Torque Fashions Limited sheds 7, 9 & 13

Paragram, Ashulia, Ashulia Bazar, Dhaka, Bangladesh
(23.877551, 90.332523)

1st & 17th September 2019

Observations

Mismatch in as-built drawings

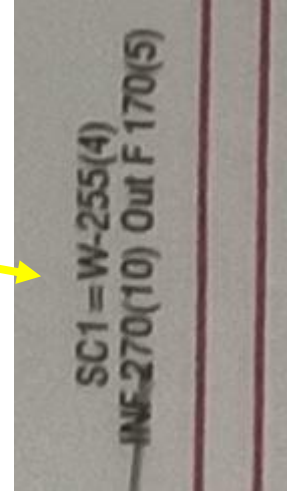
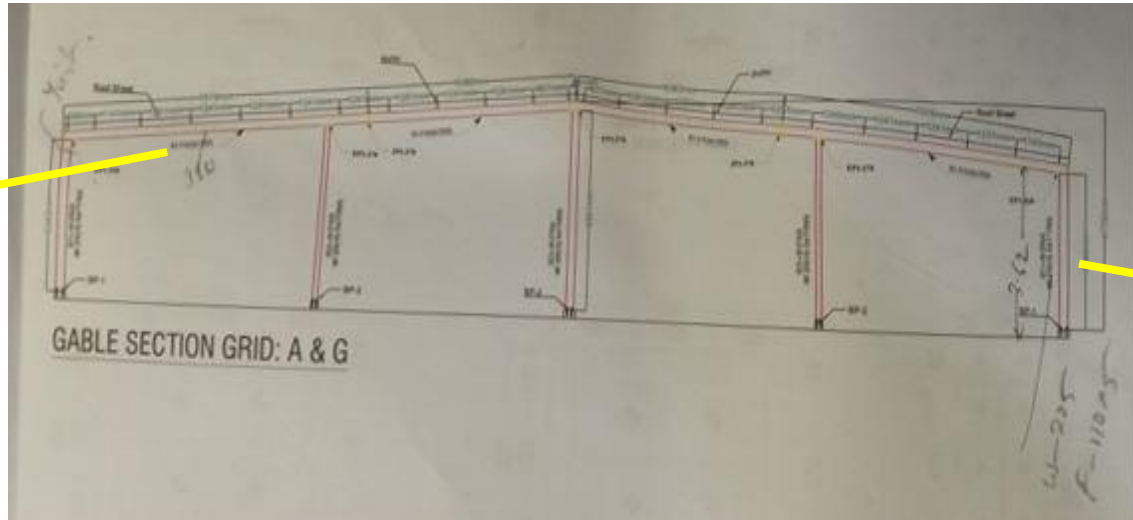
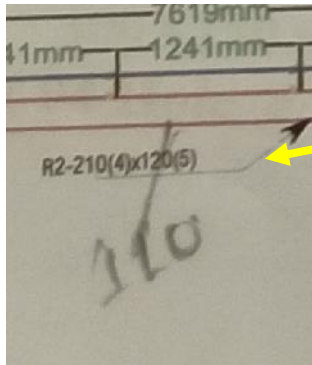
Column (SC-1) and rafter (R1) size of grid A & G were found different from provided drawing.
Also, connection details were not provided in structural drawing

Web length of SC-1 column was measured 225 mm instead of 255mm and length of flange was measured 110 instead of 170 mm.

Sectional details of grid-1

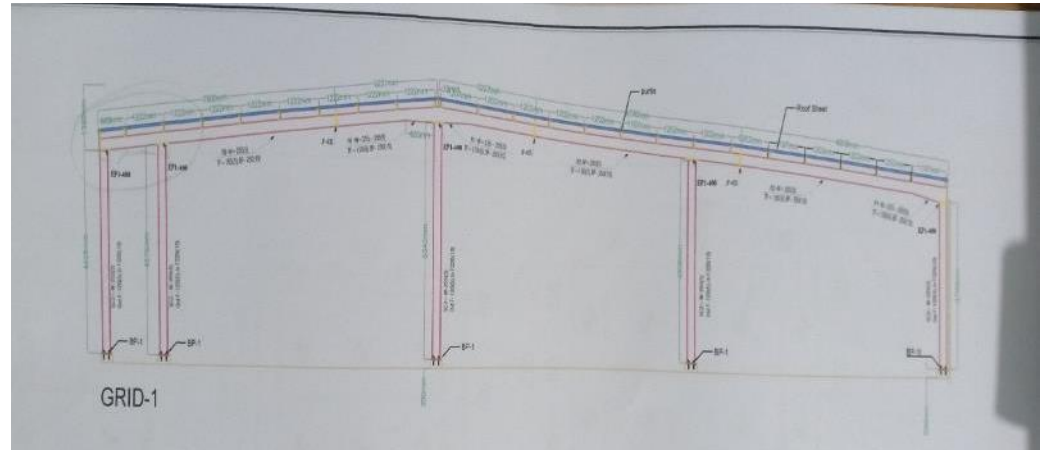
Size of column base plate and section of grid-1 didn't match with as-built drawings. Also connection details are not shown in provided drawings.

No rafter in marked location

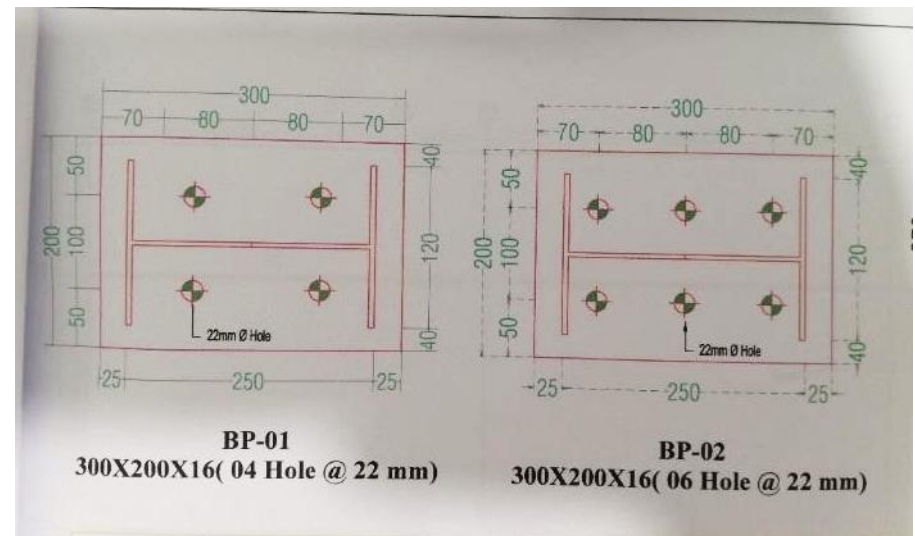
Width of base was measured 150mm instead of 200 mm

Shed-7

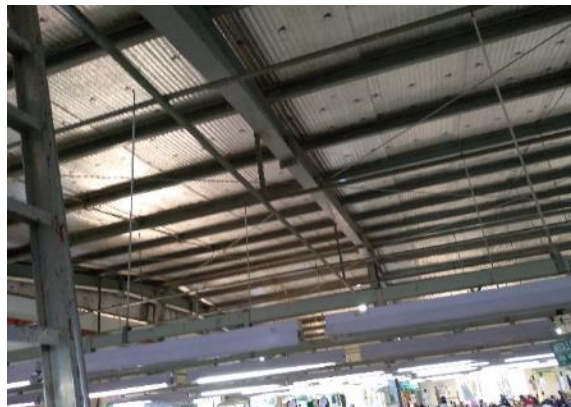
Vertical bracings were designed as stability system against lateral loading. But no compression strut member was observed in long direction. Also, vertical bracings were found missing and existing bracings were loose at several locations. The building engineer is required to check the lateral stability system of the structure against the lateral loads.

Gap in between beam-column joint

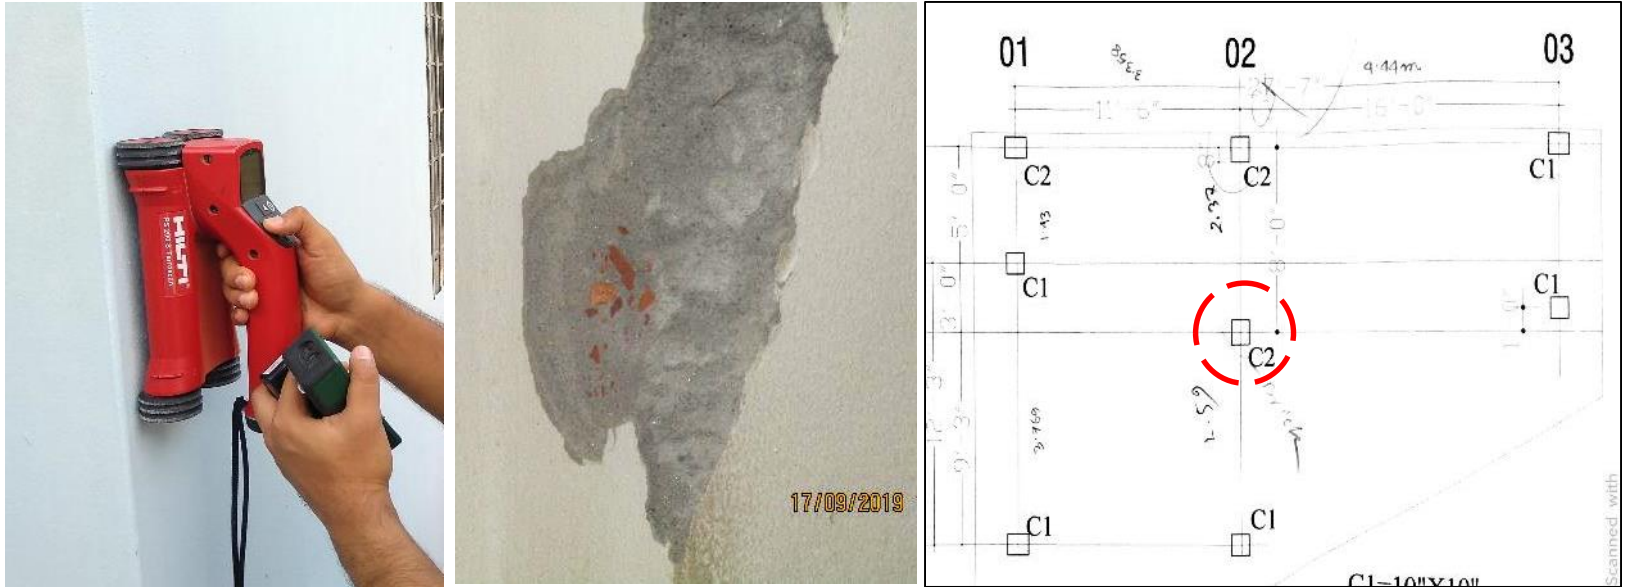
Significant gap and bolt missing in the beam-column joint

Bolt missing and significant gap found in the beam-column joint in almost all sheds of the factory. The factory Engineer is required to investigate the connections and take necessary remedial measures where required.

Bolt missing in connection
